MEMORANDUM

FROM: Todd Taylor, Environmental Review Team *TD*

**SUBJECT: ZMAP-2010-0001 and SPEX-2010-0003
HS-7 Dulles South and Elementary School
(2nd Submission)**

ATTACHMENT A – POTENTIAL REFORESTATION AREAS

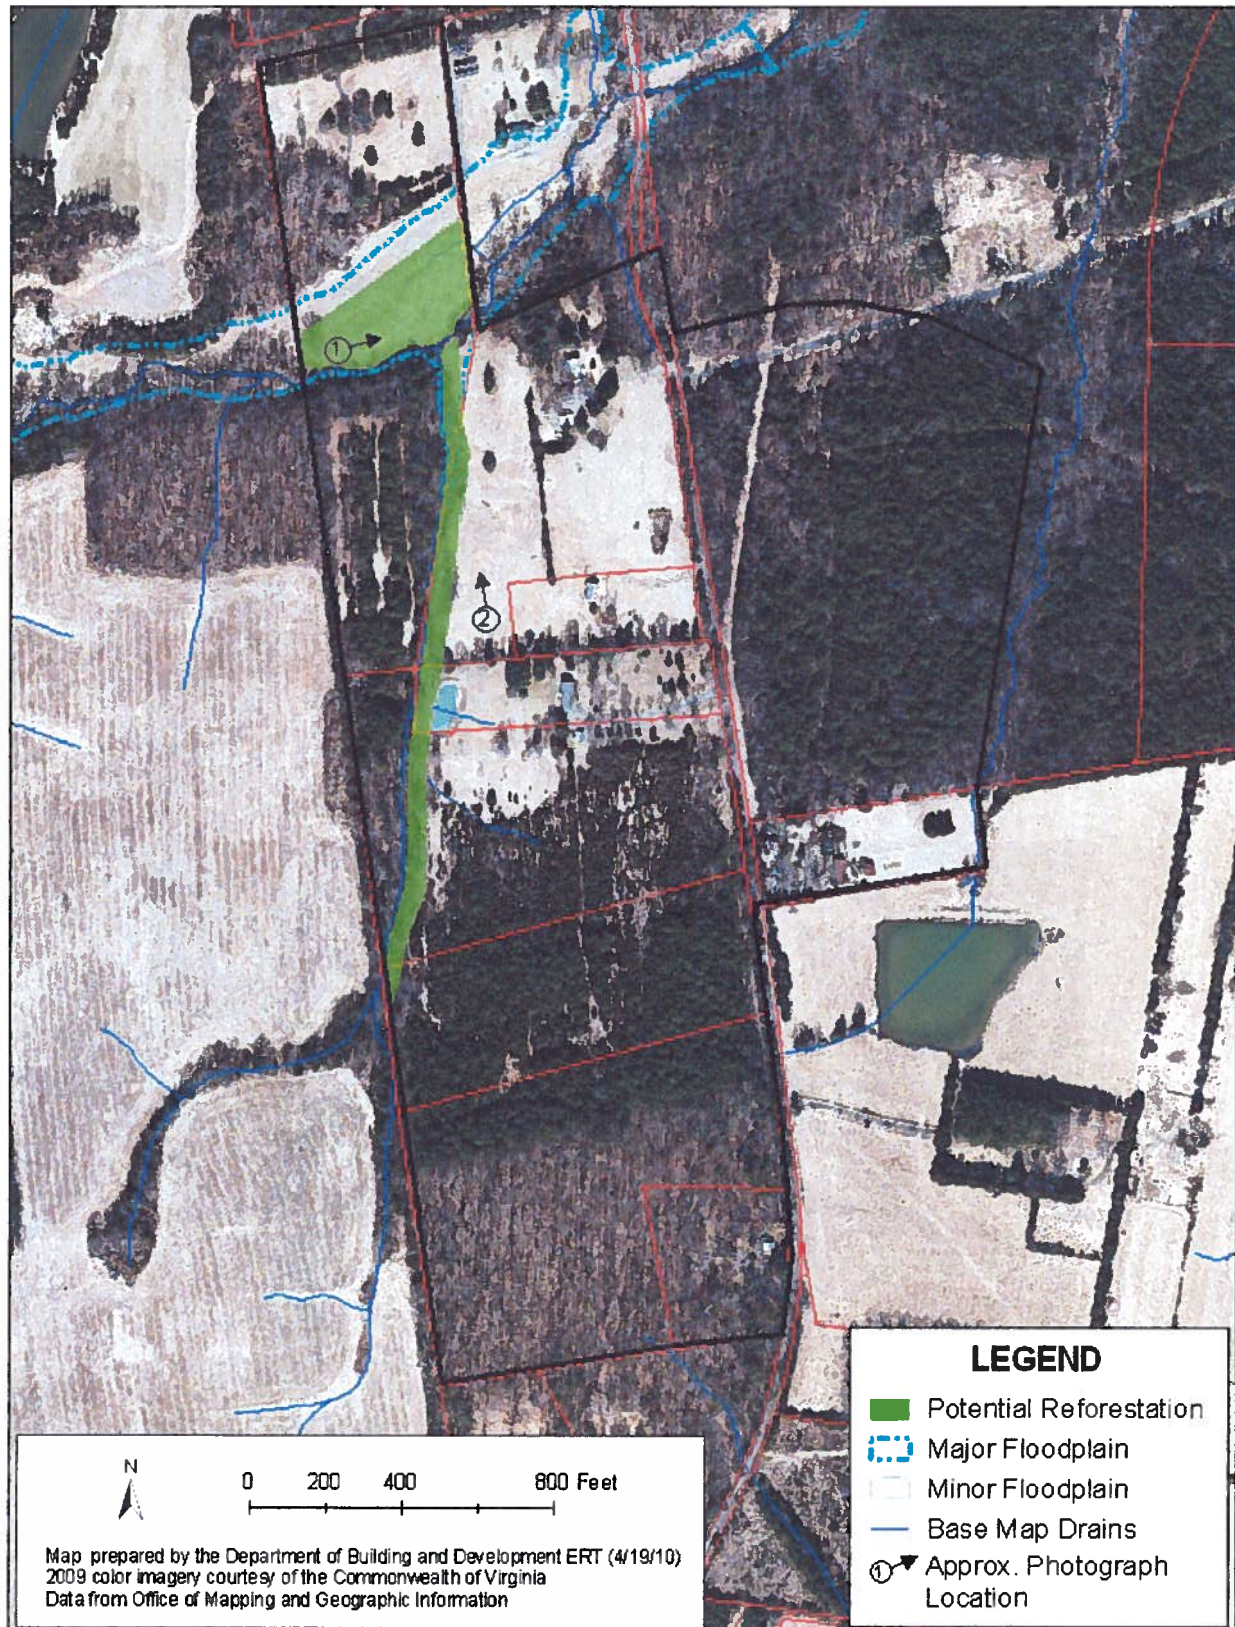
- 2) During the June 28, 2010, site visit, two reforestation opportunities were identified and discussed: 1) open floodplain immediately adjacent to the South Fork of Broad Run, including the emergent wetland, outside of the existing and proposed sanitary sewer easements; and 2) open areas within the 50-foot GI Buffer, adjacent to the intermittent stream in the western portion of the property, outside of the proposed sanitary sewer easement. Based on site conditions, deer browse potential, and minimizing cost, the County Urban Forester recommends the use of 3-gallon containerized materials within the floodplain and bare root seedlings with tubes outside of the floodplain. Staff recommends that the reforestation areas be identified

on sheets 3 (Special Exception/Rezoning Plat) and 6 (Water and Sewer Facilities Map). Attachment A and Photographs 1 and 2 identify the approximate location of the reforestation areas. Staff further recommends that a reforestation commitment be provided specifying the following: 1) the applicant shall work with the County Urban Forester on the development of the reforestation plan; 2) the reforestation plan shall be submitted to the County Urban Forester for review and approval prior to the approval of the first site plan; 3) plant material shall consist of 3-gallon containerized native trees within the floodplain and bare root seedlings with tubes outside of the floodplain; 4) the reforestation shall be implemented prior to issuance of the first certificate of occupancy; 5) the applicant shall ensure a minimum of 80 percent of the initial planting is determined to be established after two growing seasons; 6) an annual inspection shall be conducted by the applicant and the County Urban Forester to verify establishment; and 7) if the 80 percent establishment isn't achieved after the second growing season, a onetime planting to bring the project to full stocking shall be conducted by the applicant.
